## Amphenol Canada Corp - Product Change Notice (PCN)

PCN Date	May 1 2019
Supplier Name:	Amphenol Canada Corp.
Amphenol Canada PCN Number	PCN-C1380
Description of Change	Change soldering pin area from matte tin to gold flash see the below picture.
Reason for Change	Optimize plating process and improve assembly process.
Summary of changes between new and old part	The termination is matte tin for old part number. The termination is gold flash for new part number.
Traceability guidelines (lot code / date code, markings, ship date...)	Pending
Last Time Buy Date	
Datasheet attached? & Filename(s)	
Qual Test data attached? & Filename(s)

# Amphenol-PCN-C1380

Old part number

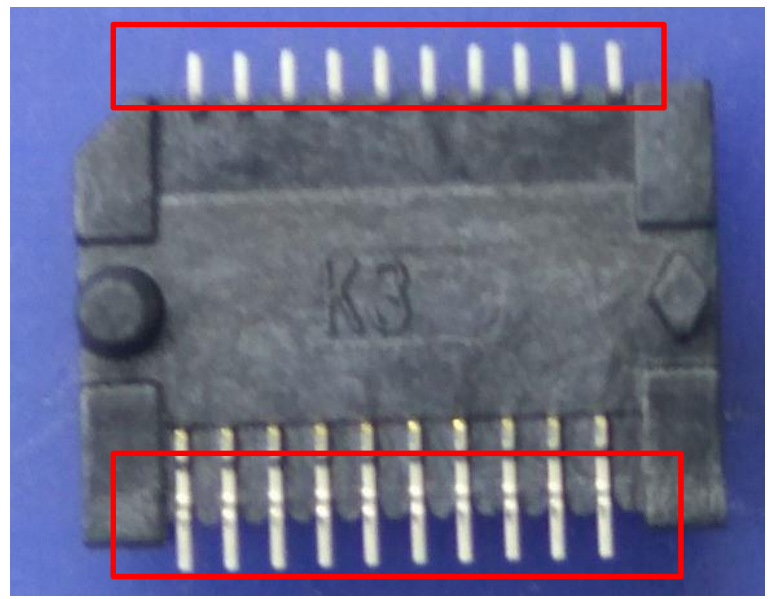
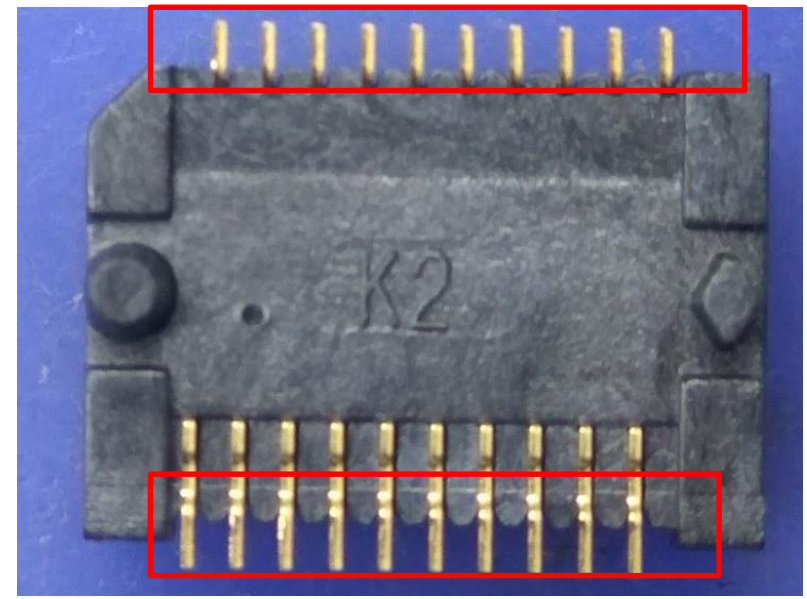
Plating gold flash on soldering pin area for new part number

New version, others are same with current product.
